Stonewater 48

RE: Stonewater 48 – Residential Amenity Compliance

APPLICANT'S BRIEF REGARDING ENCLOSURE OF EXISTING IRRIGATION DITCH

From: [David Glancey](#)
To: [Hanna Veal](#)
Subject: SUBFY2026 - 0003 - Stonewater 48 Subdivision Response
Date: Friday, October 9, 2026 5:12:49 PM
Attachments: [A-0.01 Site Plan.pdf](#)
[A-2.04 Building Type 4 Elevations.pdf](#)
[Stonewater Ditch Piped Brief.pdf](#)
[Stonewater Not in Old-Original Town Brief.pdf](#)
[Stonewater 48 – Residential Amenity Compliance.pdf](#)

EXHIBIT A

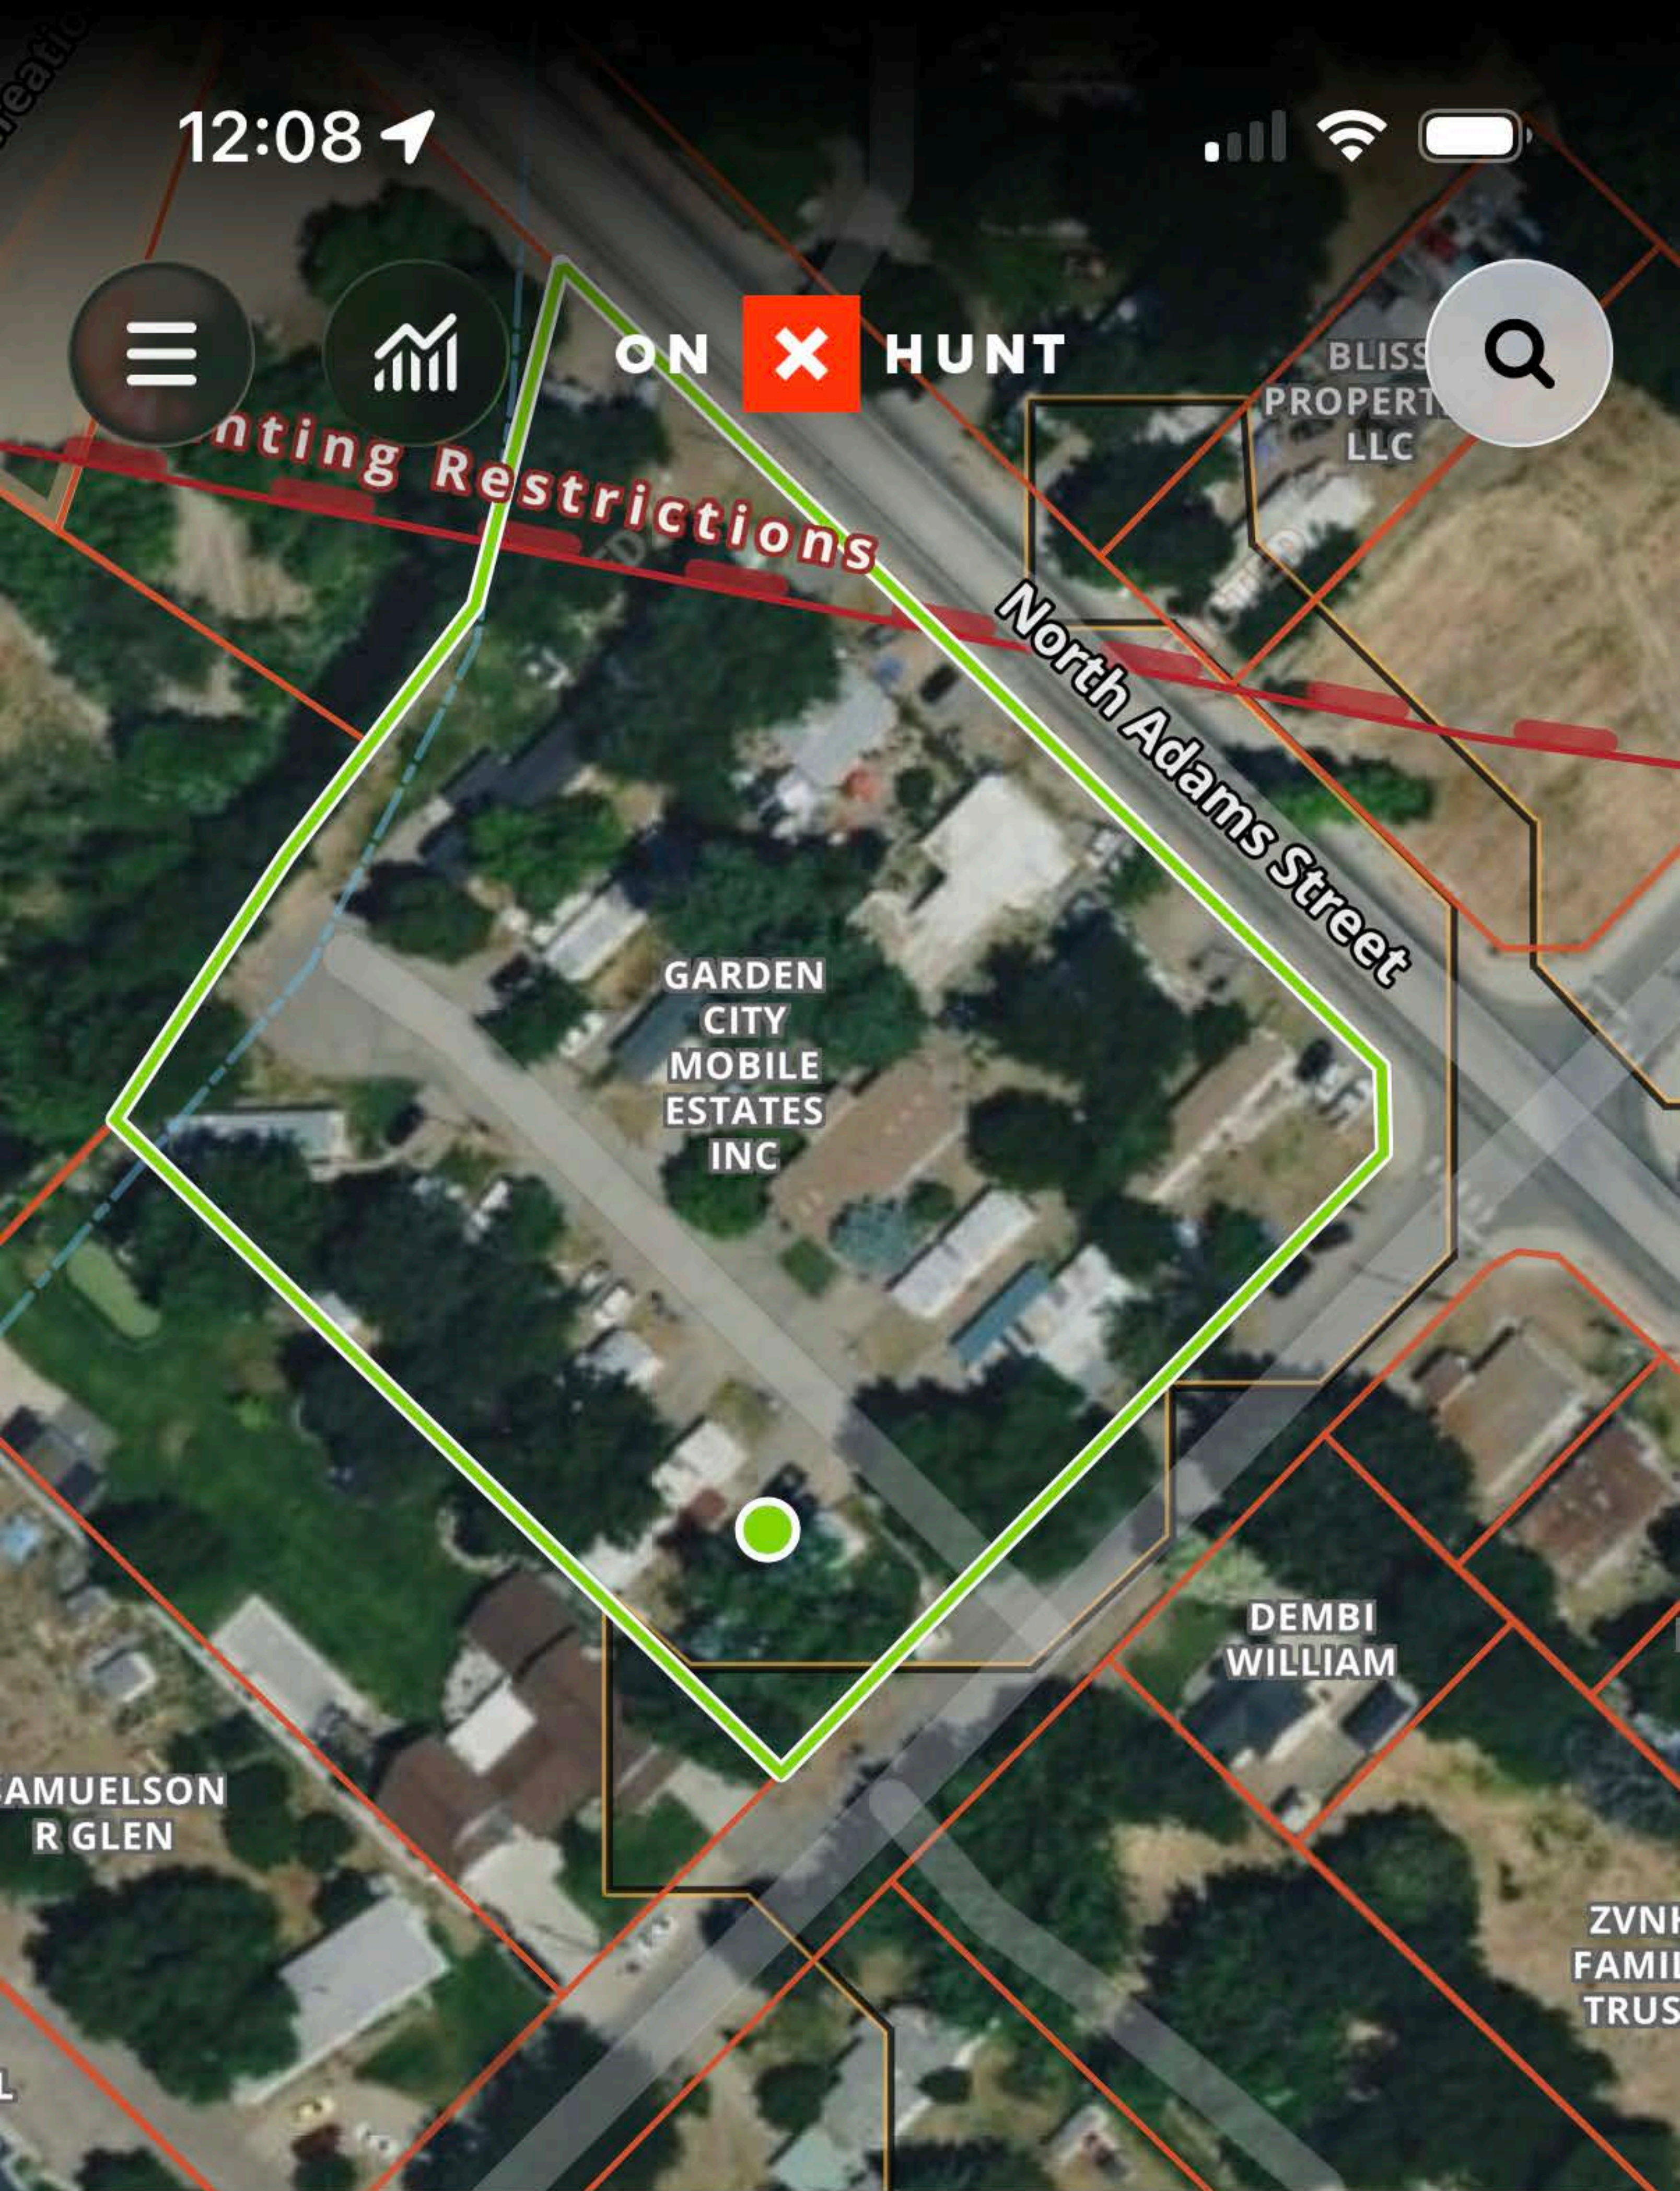
The exhibit traces the piped ditch through the properties immediately beyond Stonewater. Existing homes and other physical improvements occupy or substantially conflict with the historic/piped ditch corridor. Reopening the facility would therefore not simply require removing soil above an unobstructed pipe and converting it into an open ditch. It would require substantial alteration of existing residential development, including interference with existing homes and structures.

The aerial evidence demonstrates existing residential structures and improvements occupying the area through which an open ditch would need to pass. Reopening that facility would require substantial demolition, displacement or reconstruction of existing development.
